Los Medanos College
Campus Key Plan

CCCCD - Los Medanos

Route #1 - Los Medanos Campus

Los Medanos College
Parking Lots

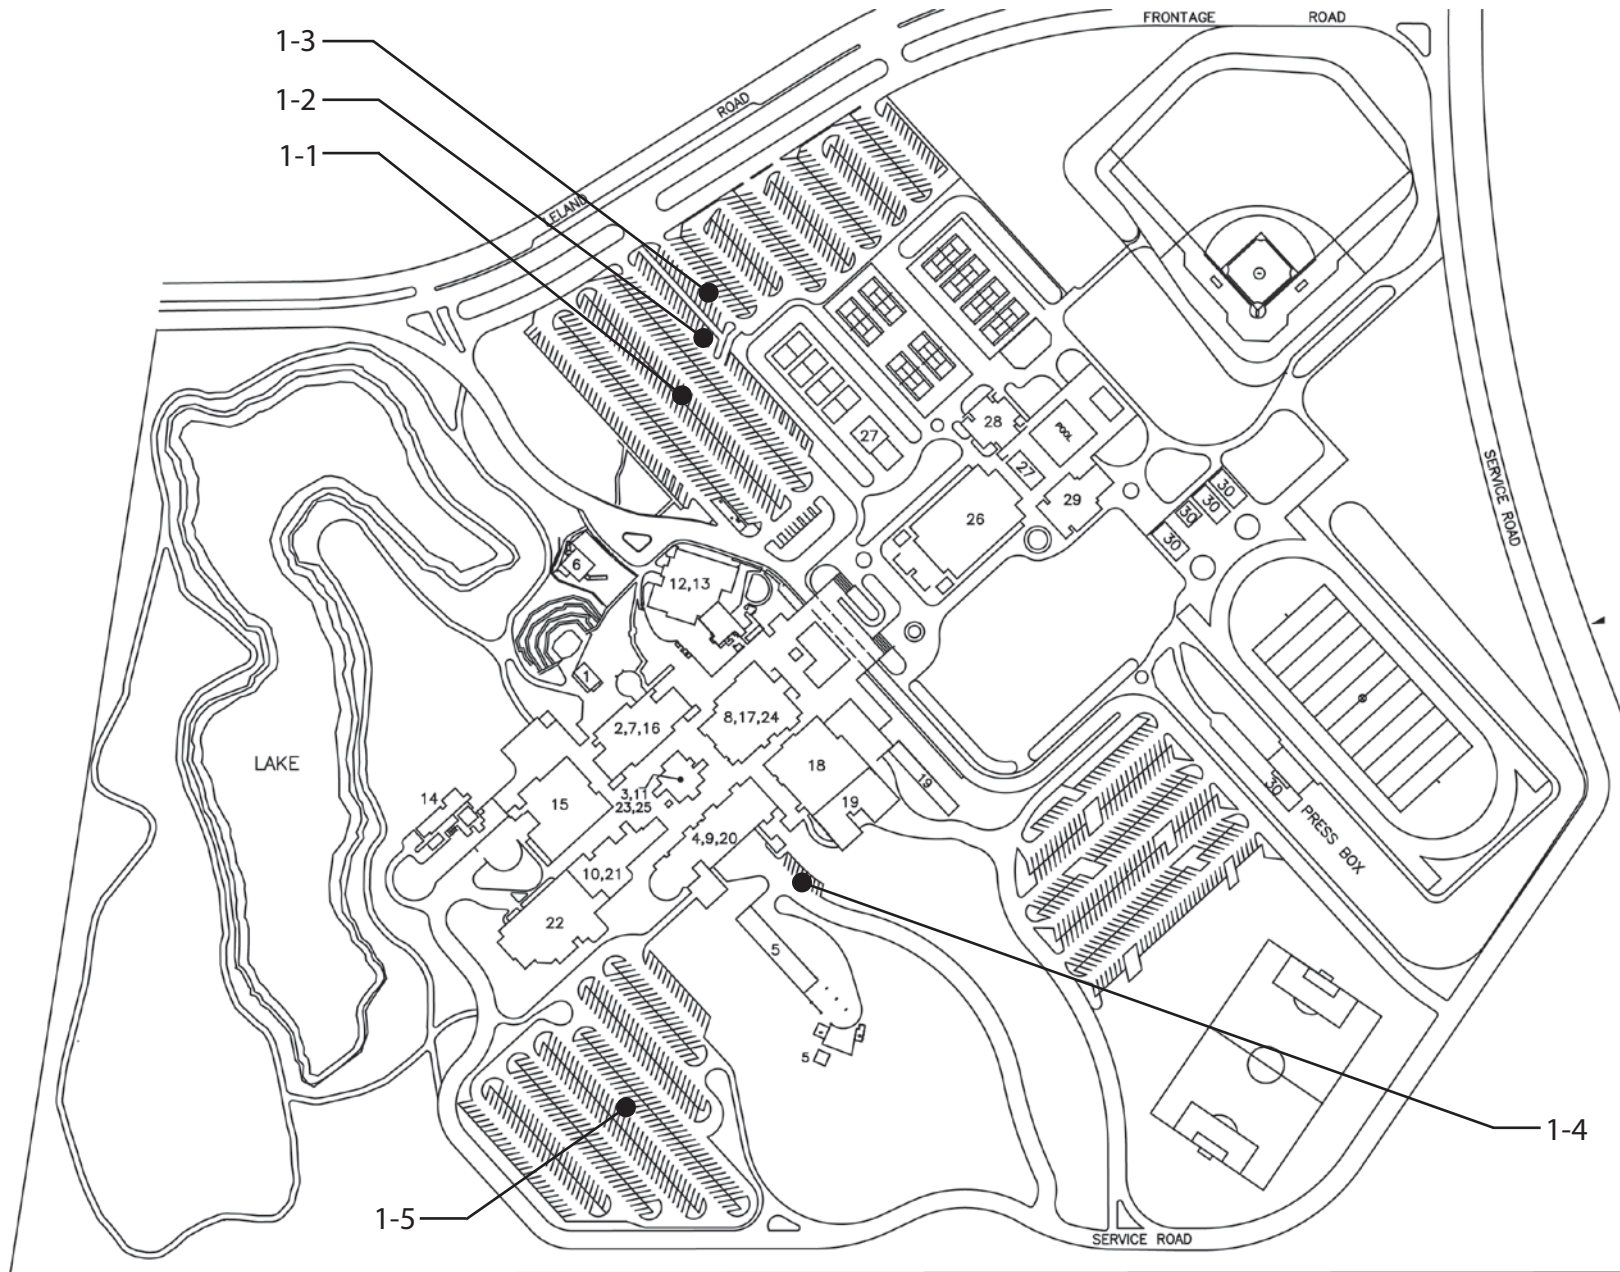
Exterior	
1 - 5	Parking Area
	Feature Priority: 1
Regrade surface	\$6,000
Notes: Slopes in five accessible parking stalls range from 2.1% to 3.1% (2% max). Slope in the access aisle is 2.5% (2% max).	
State: 1129B.3 #4	
Federal: 4.6.3	
Action Priority: S	
Install sign	\$2,600
Notes: The words 'NO PARKING' are not painted in 13 of the access aisles.	
State: 1129B.3 #1, 1129B.3 #2	
Federal: -	
Action Priority: S	
Install sign	\$600
Notes: Lot C - Signs designating accessible parking stalls are not provided for three parking spaces.	
State: 1129B.4	
Federal: -	
Action Priority: S
